SPACE VILLAGE FILING NO. 4
A PORTION OF THE NW 1/4 OF SEC. 17, T14S,
R65W, OF THE 6th P.M., EL PASO COUNTY, COLORADO
GRADING & EROSION CONTROL PLAN

ASBUILT

ASBUILT NOTE

GRADING & EROSION CONTROL PLAN (SWMP-SITE MAP)

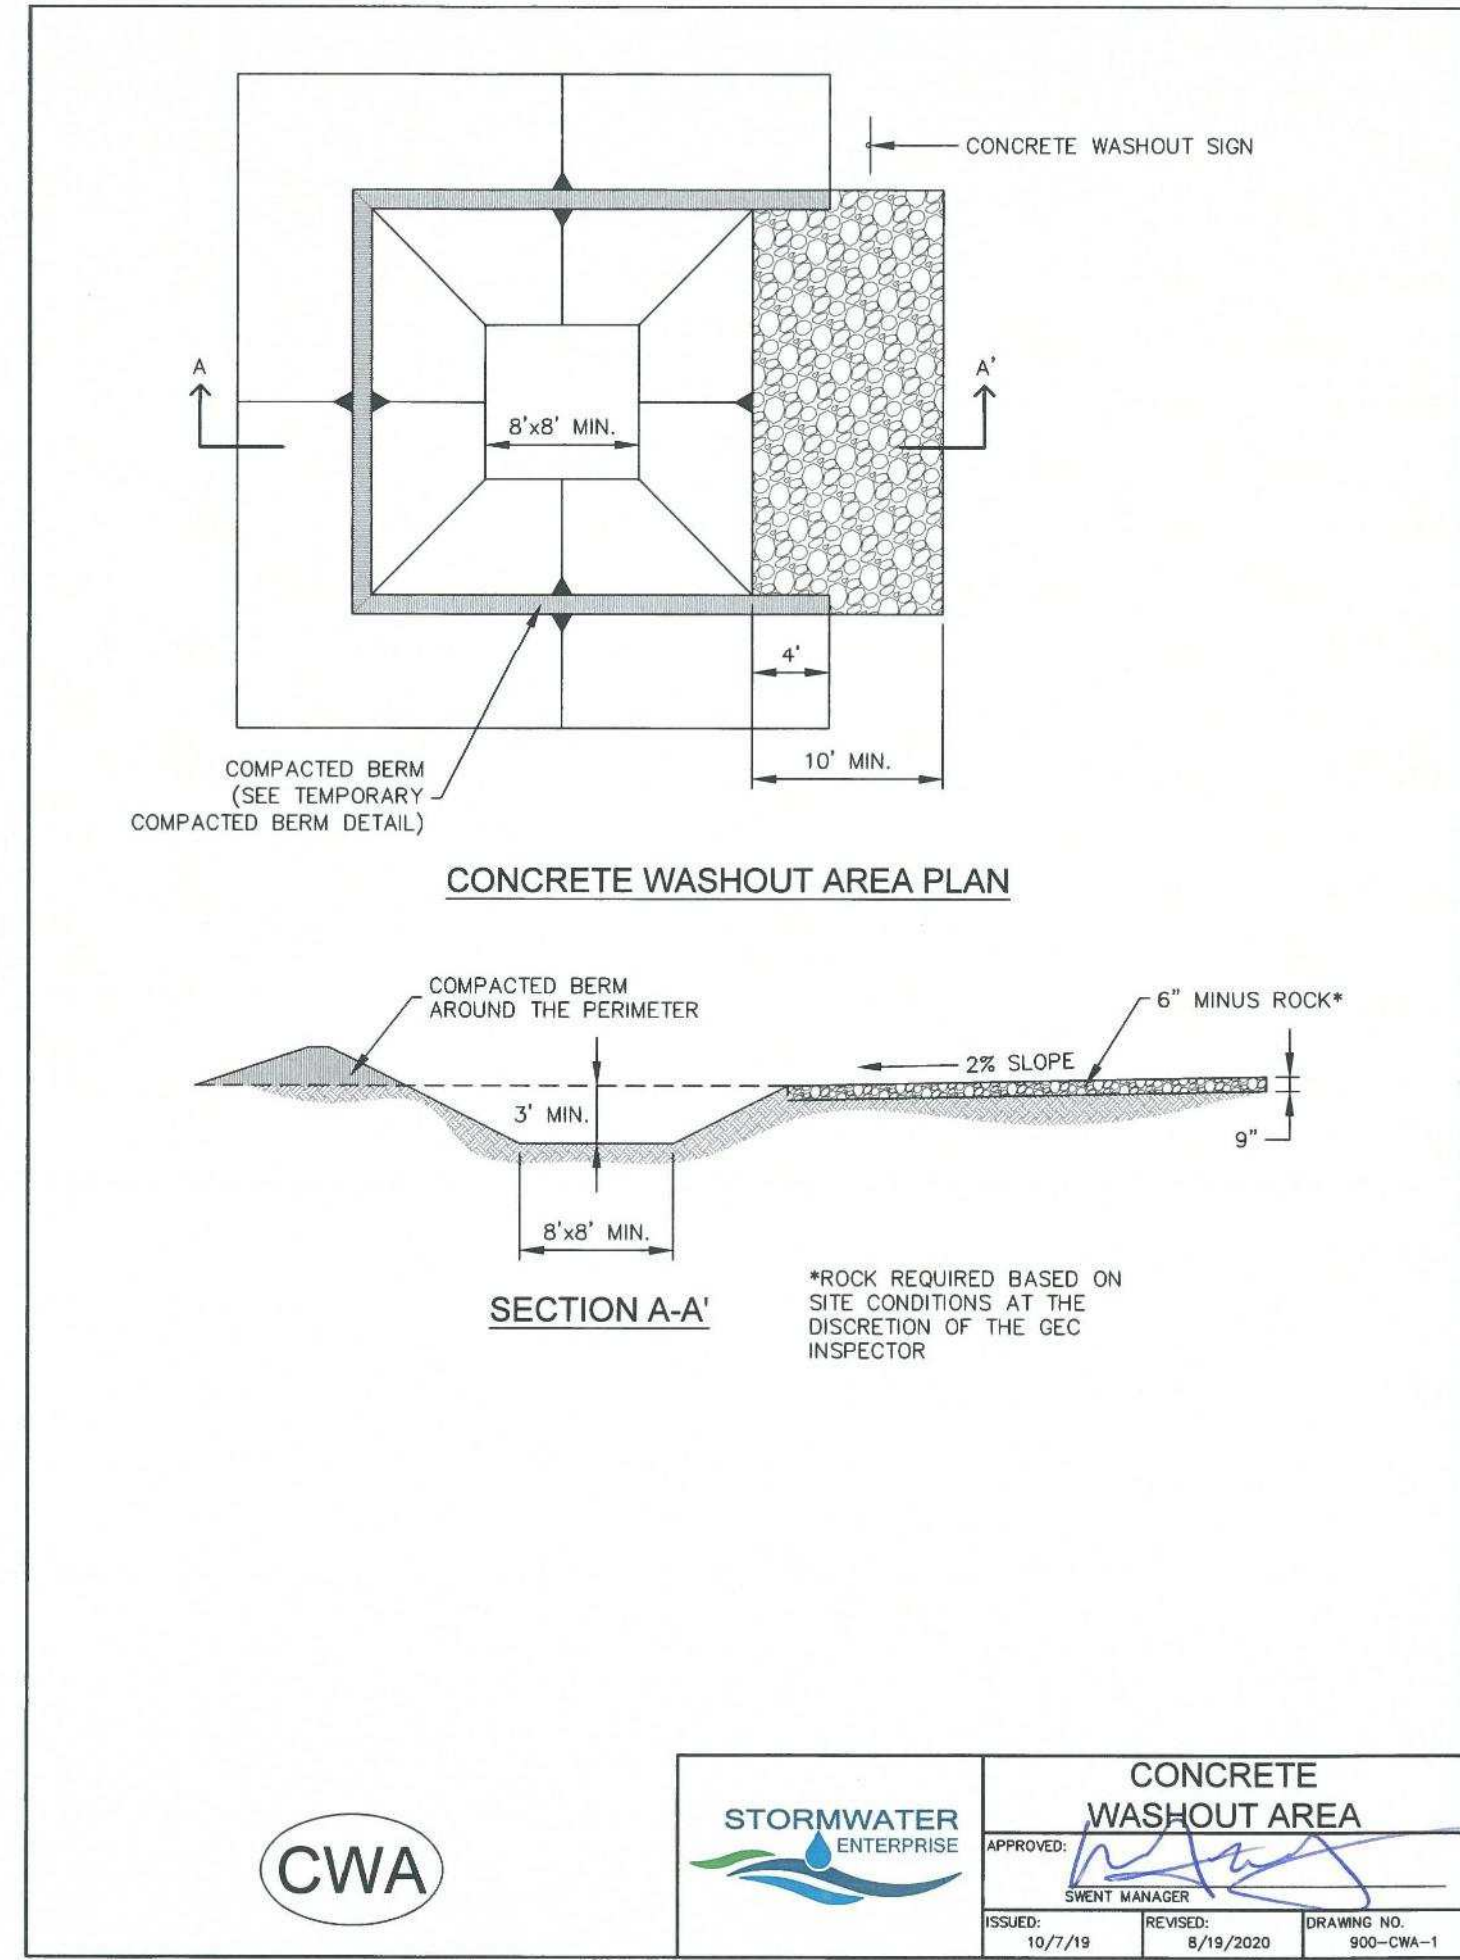
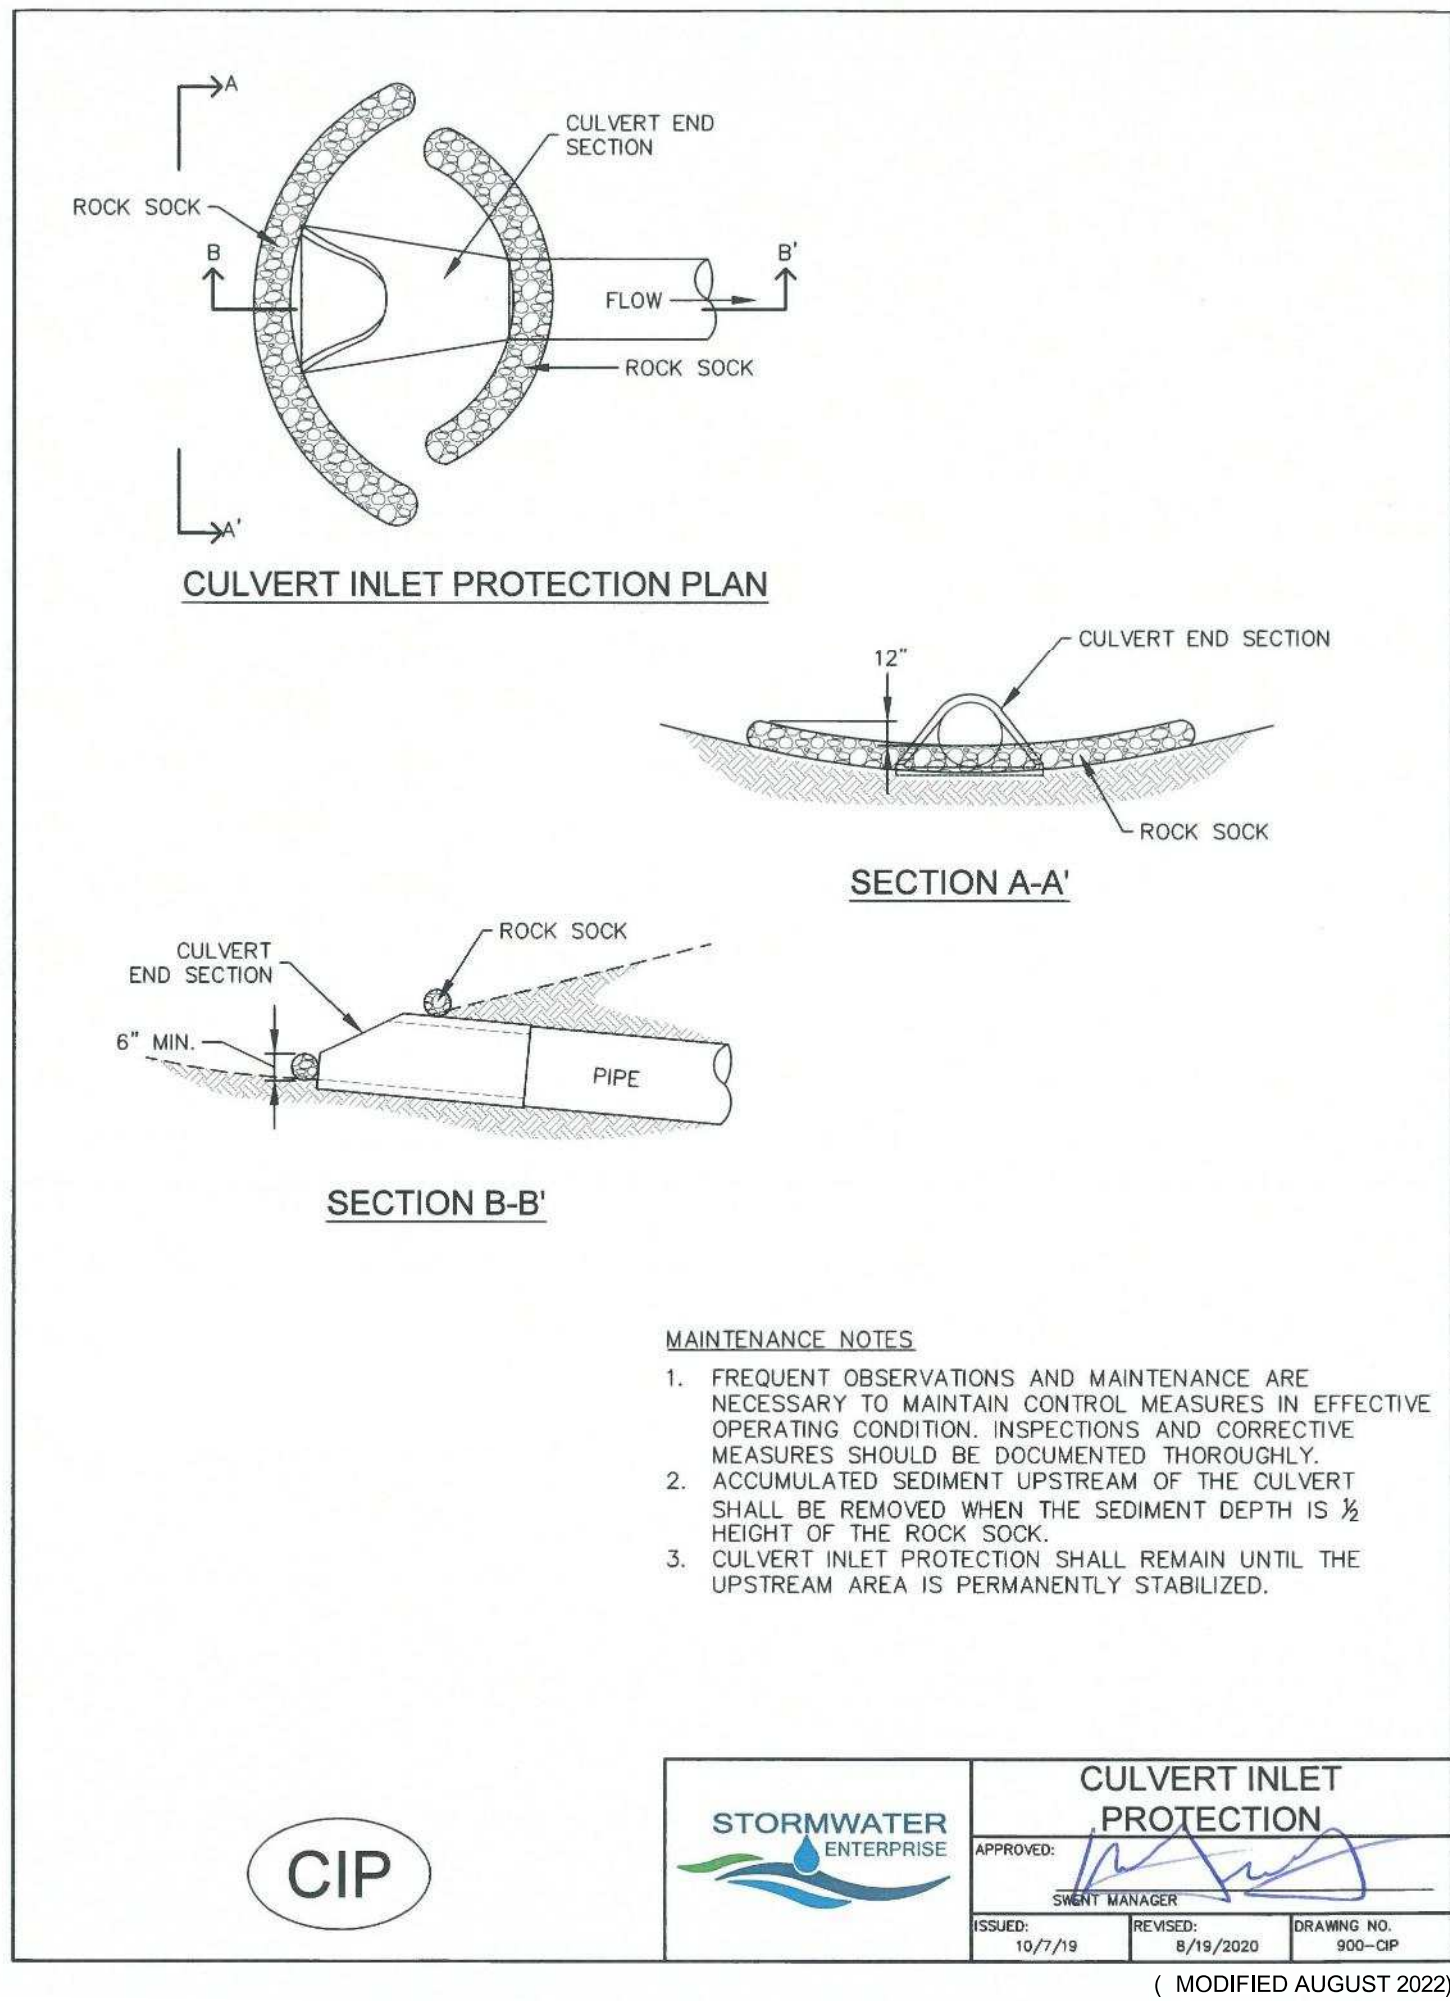
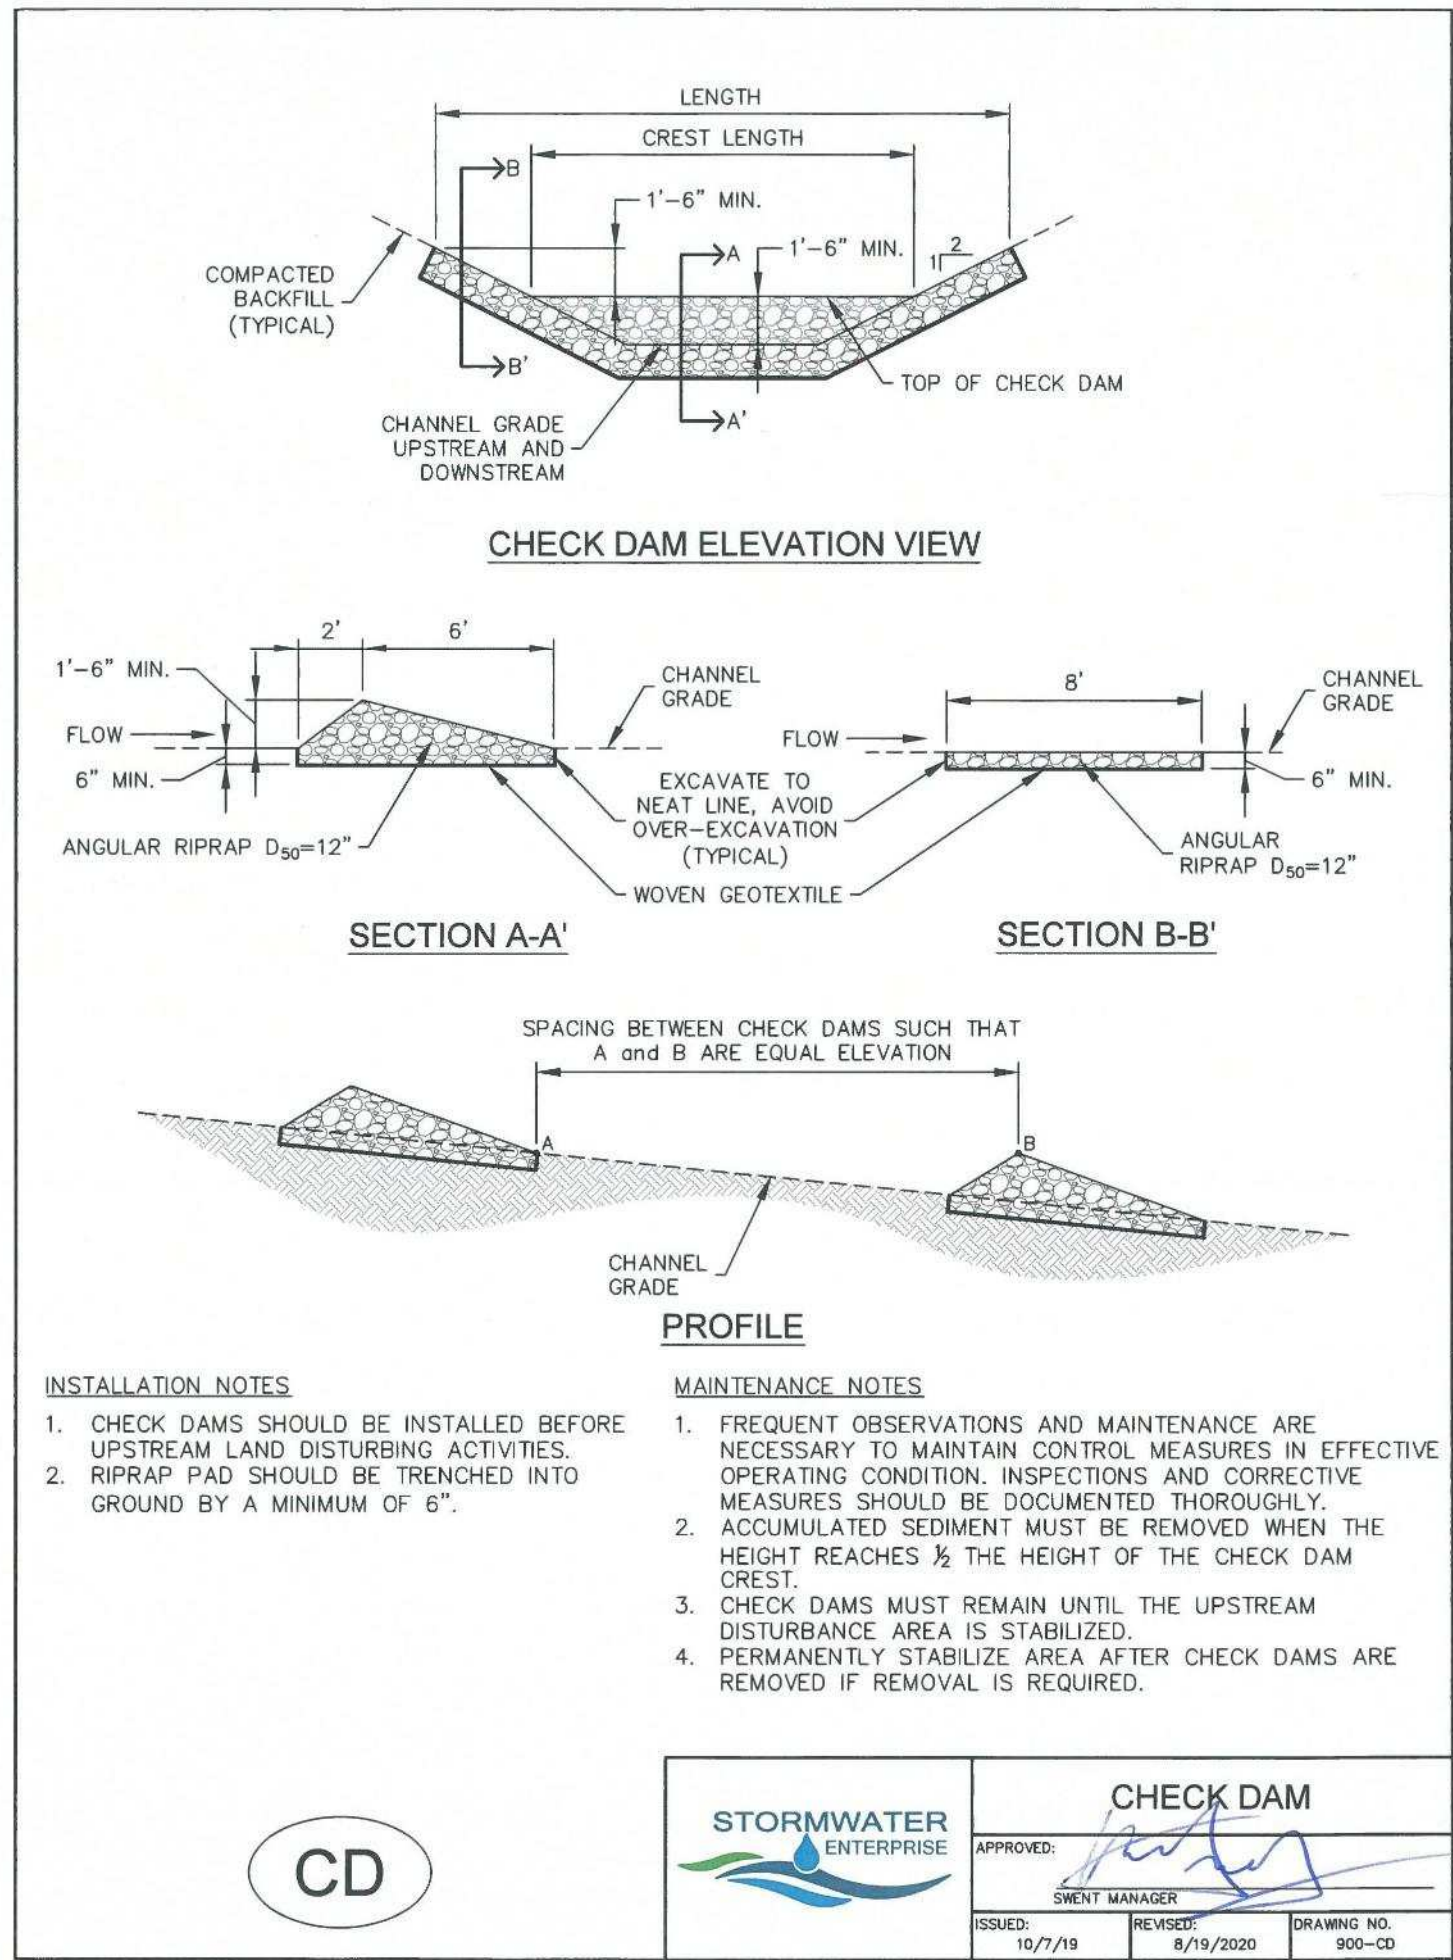
The site has not been seeded or mulched yet per the stormwater inspector. This isn't an item that can be addressed with the as-builts, just emphasizing that this is required to enter preliminary acceptance.
